**BEFORE THE COMMISSIONER APPOINTED
BY THE SOUTHLAND REGIONAL COUNCIL**

IN THE MATTER of resource consents to occupy the Coastal Marine Area with a tide gate and weir and to dam and divert water

**SUMMARY EVIDENCE OF LAURA ROSE DRUMMOND FOR
SOUTHLAND REGIONAL COUNCIL**

30 August 2024

Figure 1: Aquatic compensation locations

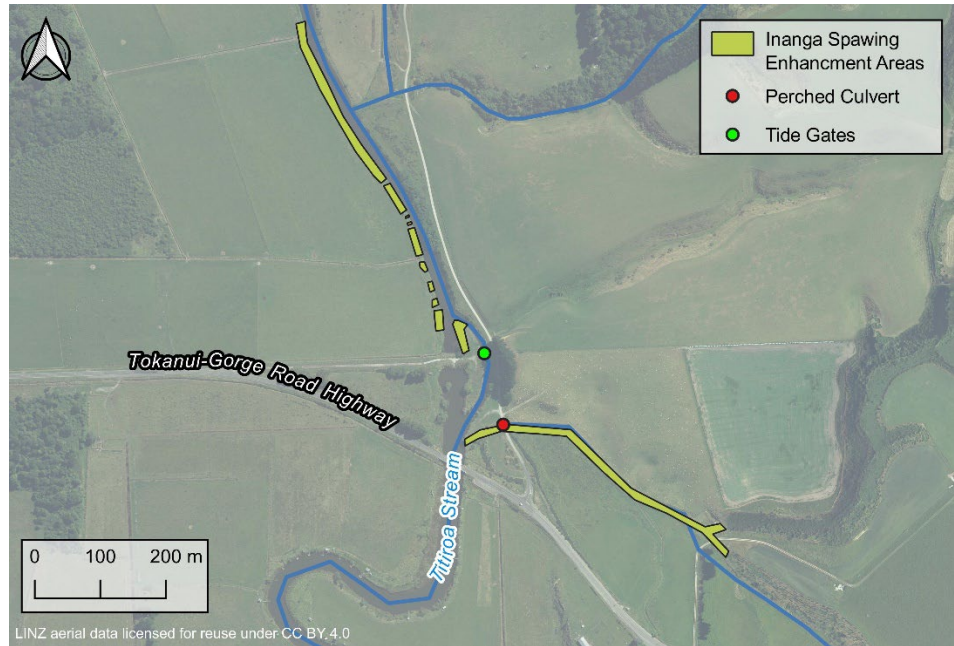
6. A range of potential enhancement options were originally provided for further consideration and consultation², which did not occur. These options have been updated in response to landowner restrictions and include improved inanga spawning habitat of the Titiroa Stream mainstem and tributary enhancement for a total area of approximately 1.1 ha. The ring drain enhancement downstream of the gates has been removed from the aquatic compensation package. A summary of the proposed mitigation and aquatic compensation is provided in Table 1, with indicative areas shown in Figure 1. A Habitat Enhancement Management Plan is proposed as a condition of consent (condition 4 & 5) to provide confirmation of the areas and methodology of habitat enhancement, and associated monitoring to confirm success.

19. In paragraphs 67-68 of Ms Bowen's evidence she discusses the mitigation/offsetting proposed in the mitigation options report¹⁰ and how that compares to what is being currently proposed. A smaller area of aquatic compensation habitat has been proposed, outside of any consultation occurring. This is because of landowner and budgetary constraints of the Council. I agree that further detail is required, this is proposed to be provided in the Habitat Enhancement Management Plan.

18. I agree with Ms Bowen⁷ in that the outcome of inanga spawning is uncertain, however note that it would be an improvement on current conditions. Further clarity on the proposed approach (battering of banks to reduce the grade, riparian planting) will be provided in the Habitat Enhancement Management Plan. Land area to undertake enhancement is limited, due to landowner restrictions. Currently available areas have been identified as:

- (a) Bank areas along the mainstem of the Titiroa Stream upstream of the gates (0.6 ha).

- (b) The tributary on the true left bank downstream of the gates (0.5 ha). This tributary was chosen as previous investigations⁸ into potential inanga spawning areas in Southland rivers highlighted this location as having a salt wedge. There is currently a perched culvert on this tributary, which is proposed to be remediated to improve fish passage at this location.

- (c) The ring drain downstream of the gates⁹ was selected as an option as it is Environment Southland land that can be accessed near the gates, with potential to be modified to provide for native fish habitat. I agree with Ms Bowen that the ring drain downstream of the gates, in its current form, is not suitable for inanga spawning enhancement. It was intended that alteration to the outlets would be required to improve native fish habitat (and potentially inanga spawning habitat). However, considering the changes to the outlets that would be required, and the now proposed tide gate mitigation, this option has been removed from the compensation list.
